Los Angeles to Pasadena Metro Blue Line Construction Authority
Los Angeles to Pasadena Metro Blue Line Light Rail Project

Value Engineering Study Report

Preliminary Basis for Design/Build Design

December 22, 1999

CONTRACT NO	C6420
DRAWING NO	U-0207
SCALE	HORIZ 1" = 40' VERT 1" = 10'
SHEET NO	364

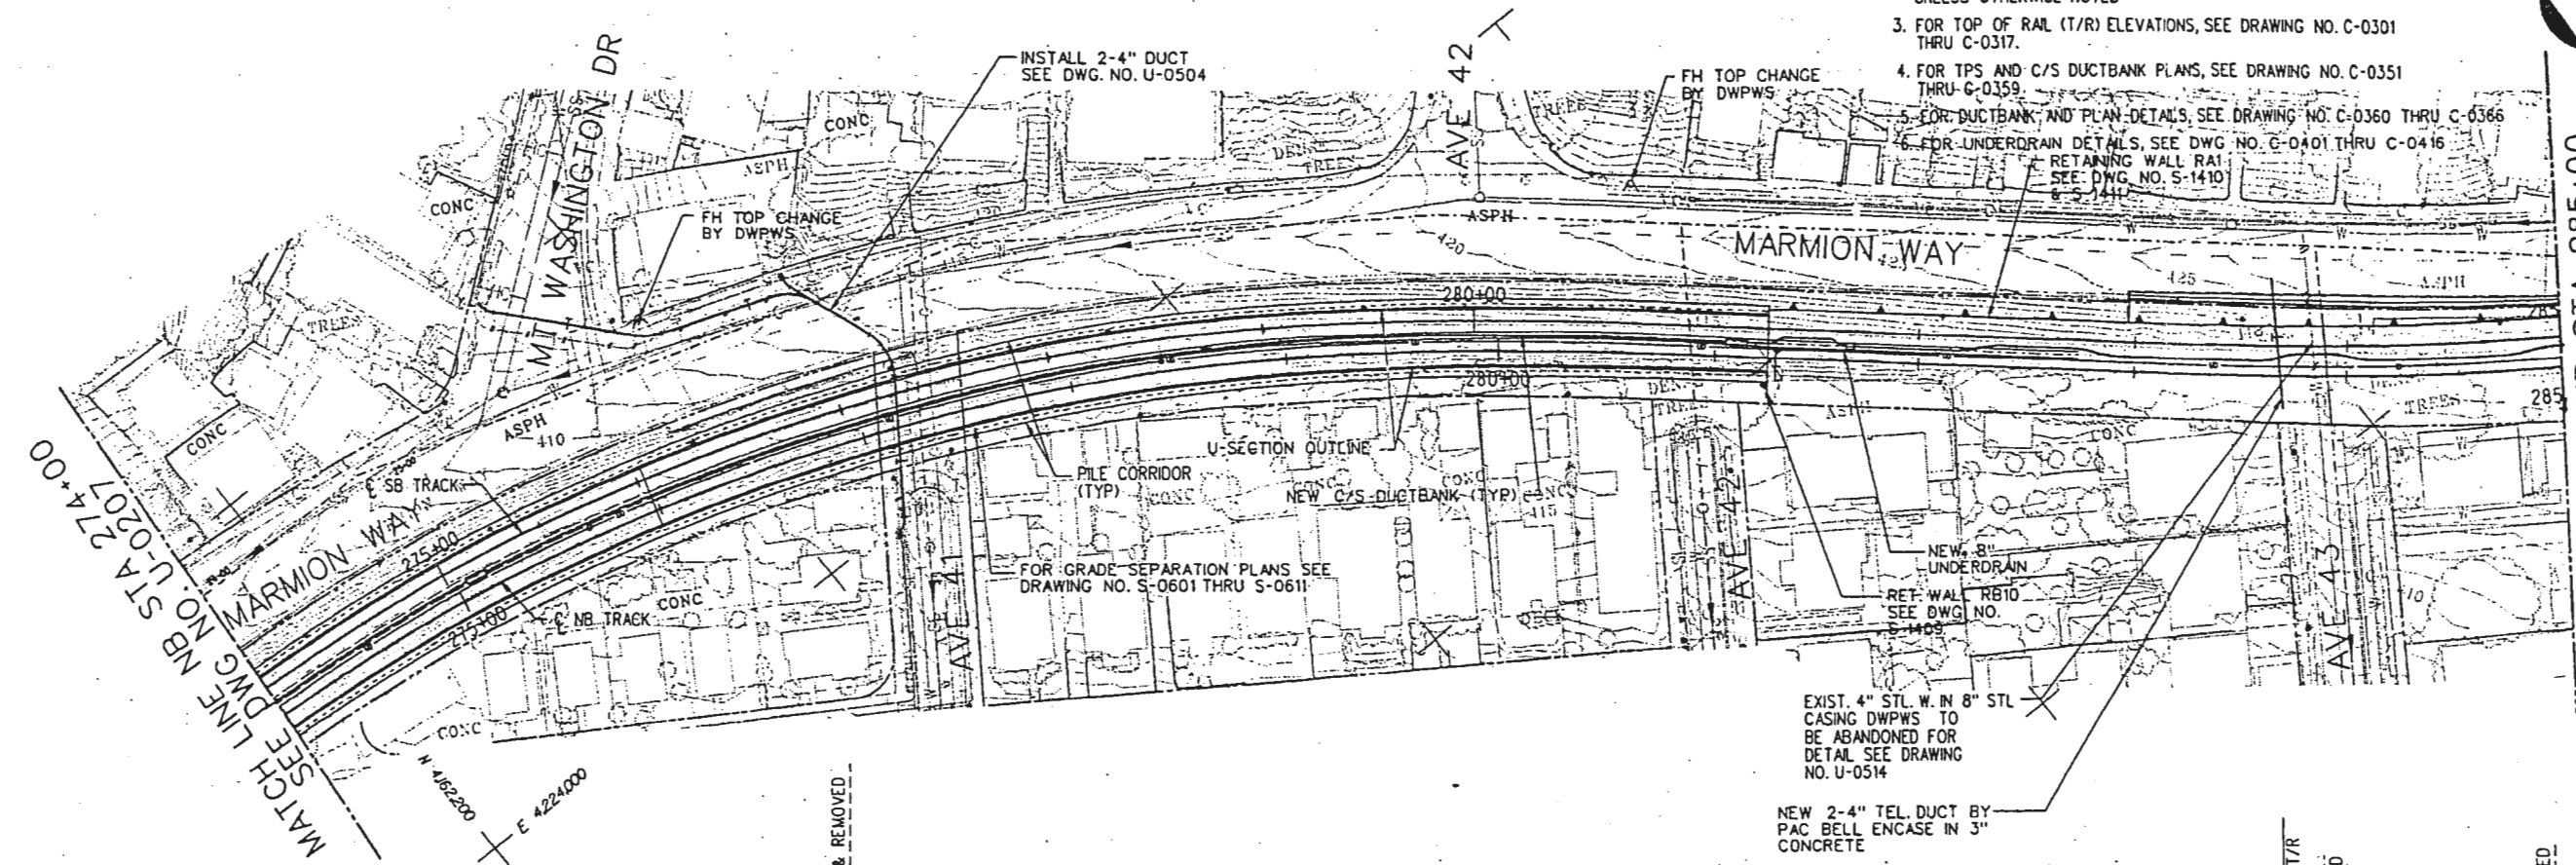
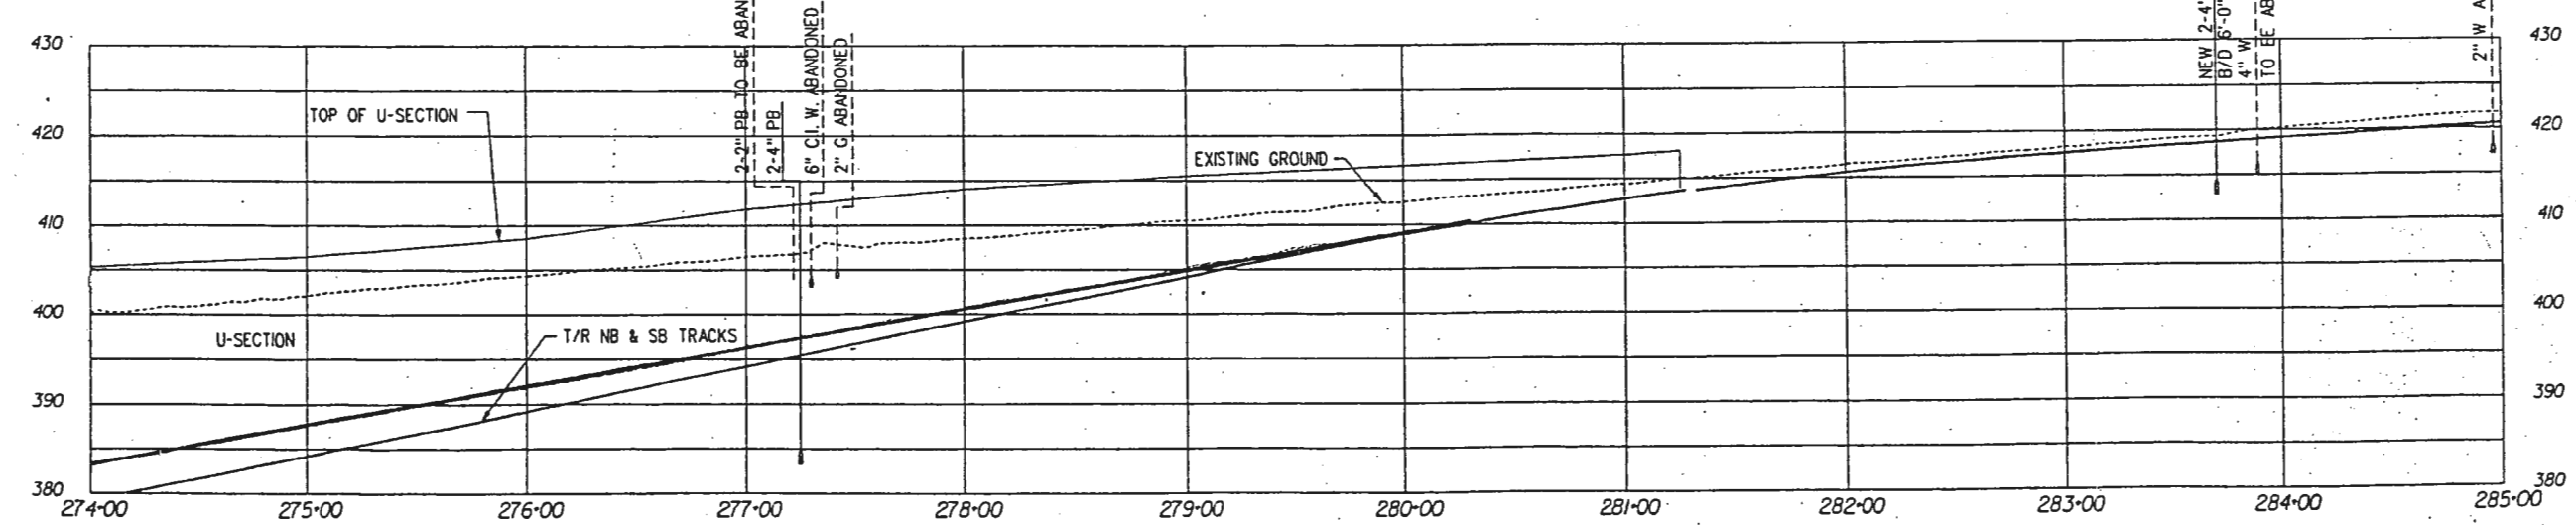
Intercept the two sanitary sewers on the cast side of the new grade separation box structure. Provide a 36-inch diameter sanitary sewer along the east grade of the tunnel and "U-Section" of the light rail line. Connect the sanitary saver line to the existing sanitary sewer at the intersection of Arroyo Seco Avenue and 37 Avenue. Raise the track profile so that the control for the box structure is the bottom of the 27-inch diameter storm drain in Figueroa Street. Reconfigure the storm water reservoir and place it under a portion of the tunnel. Locate the sump pumps station at the northeast corner of Figueroa Street and the light rail crossing.

ALTERNATIVE NO.
LAR-7
Sht 2 of 6

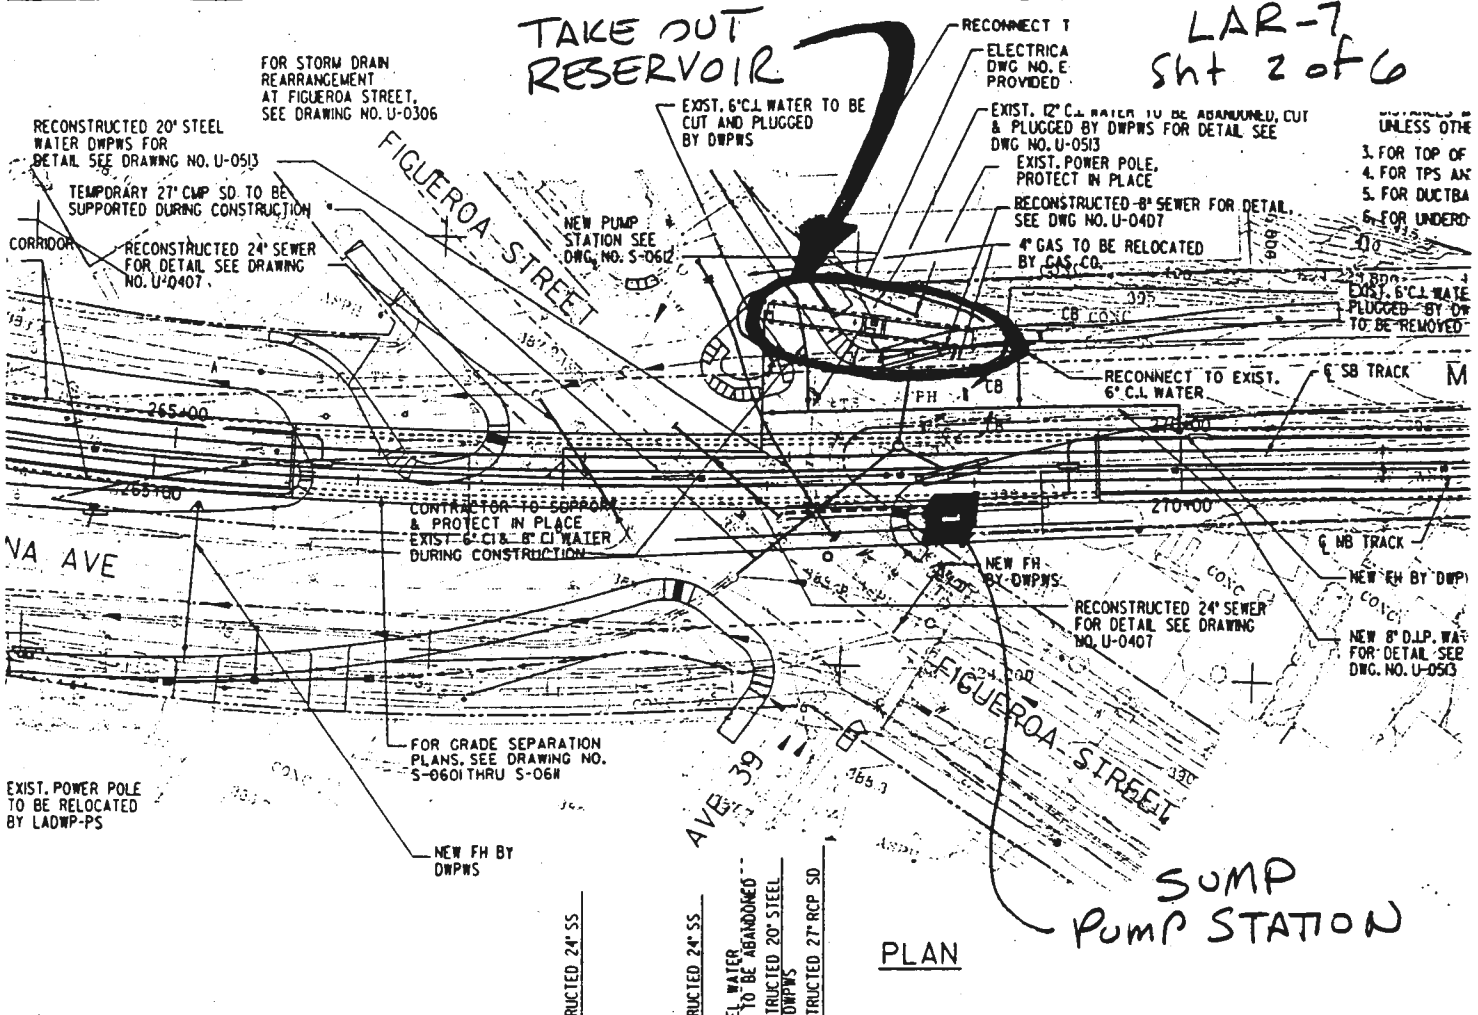
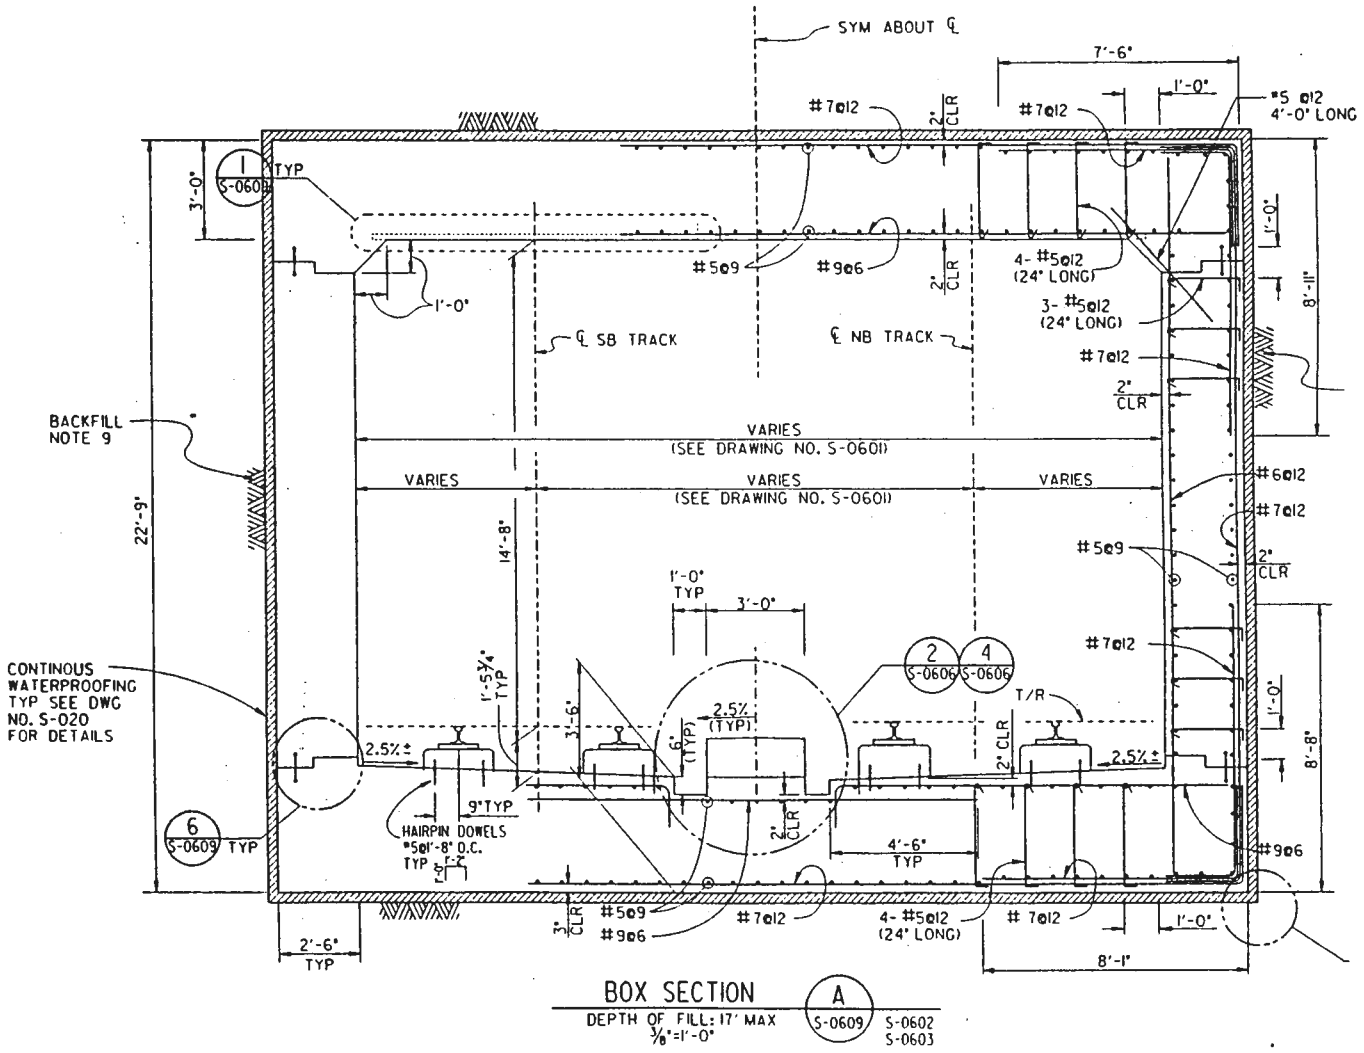
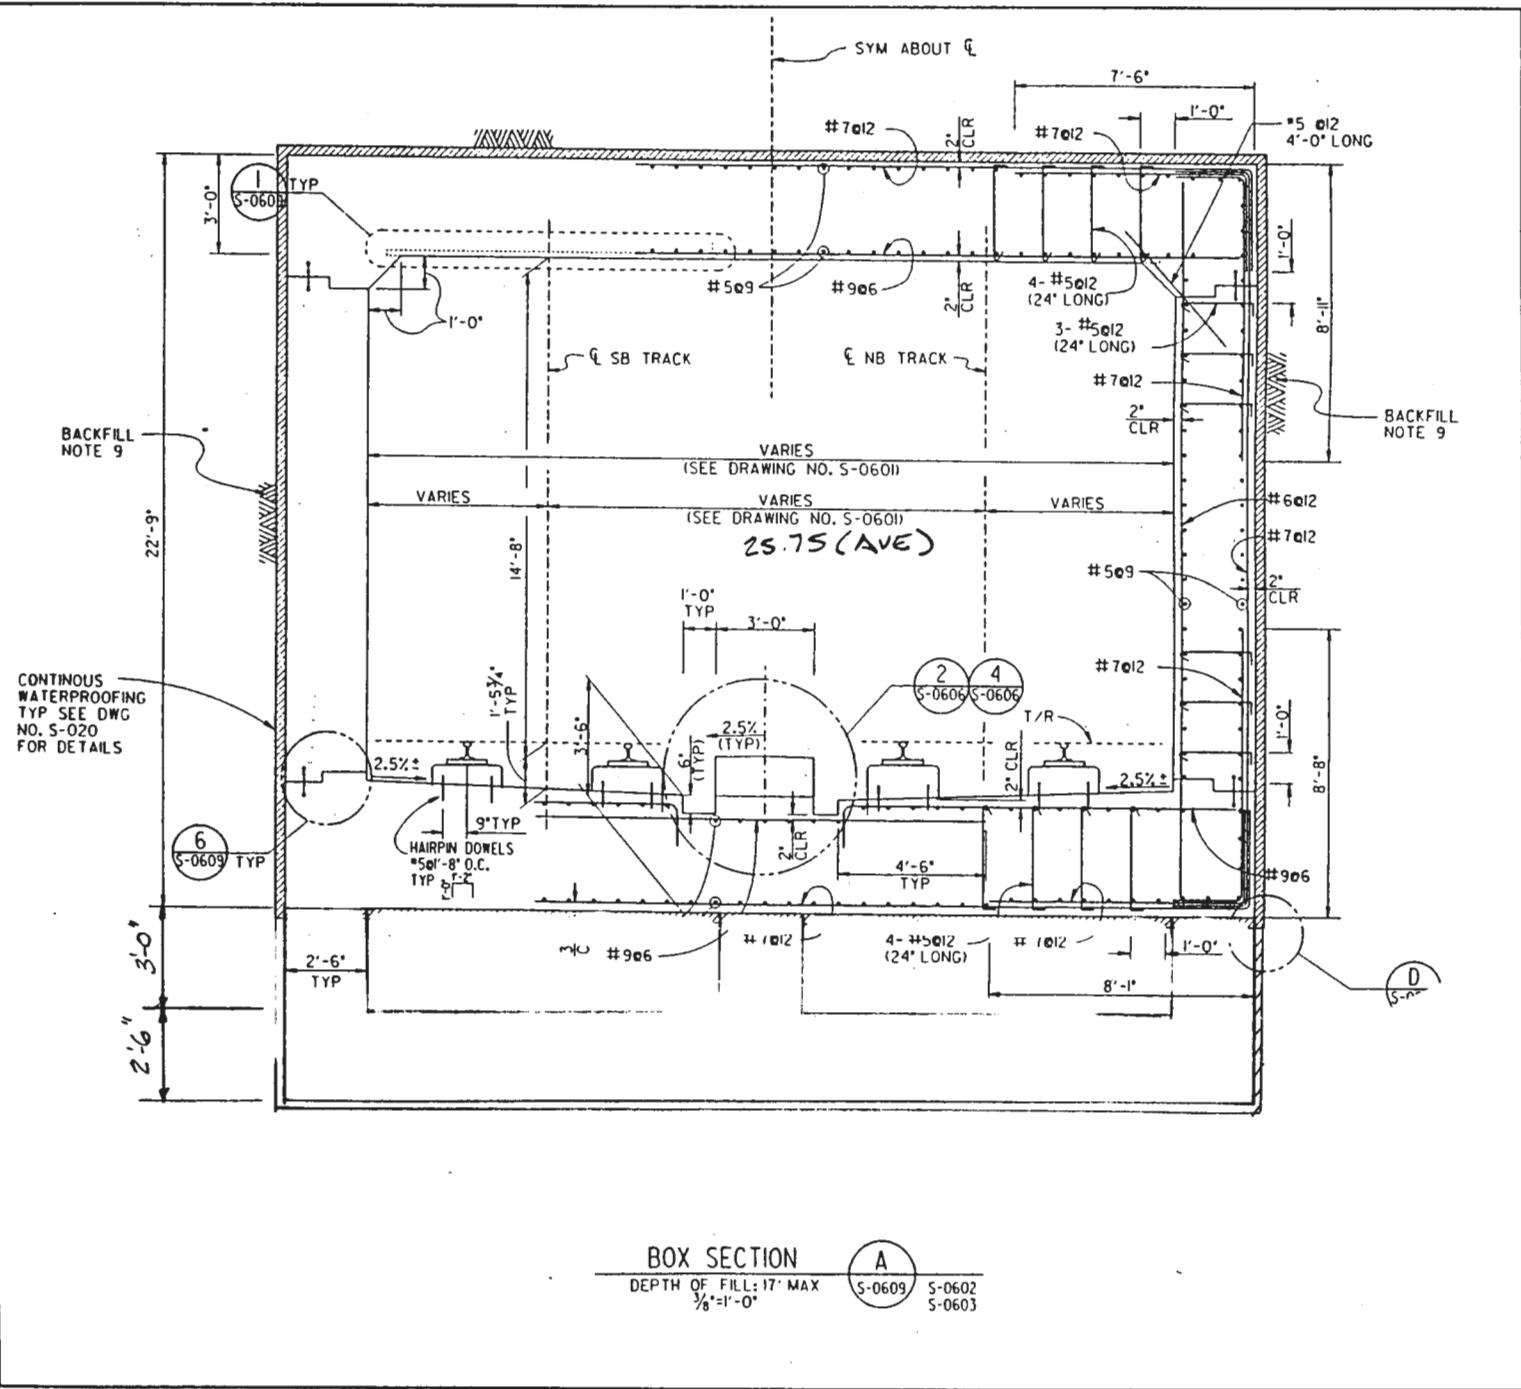
PROJECT:	PASADENA BLUE LINE LIGHT RAIL PROJECT	ALTERNATIVE NO.	LAR-7
DESCRIPTION:	PLACE RESERVOIR UNDER FIGUEROA STREET GRADE SEPARATION	SHEET NO.	1 of 6

TAKE OUT
RESERVOIR
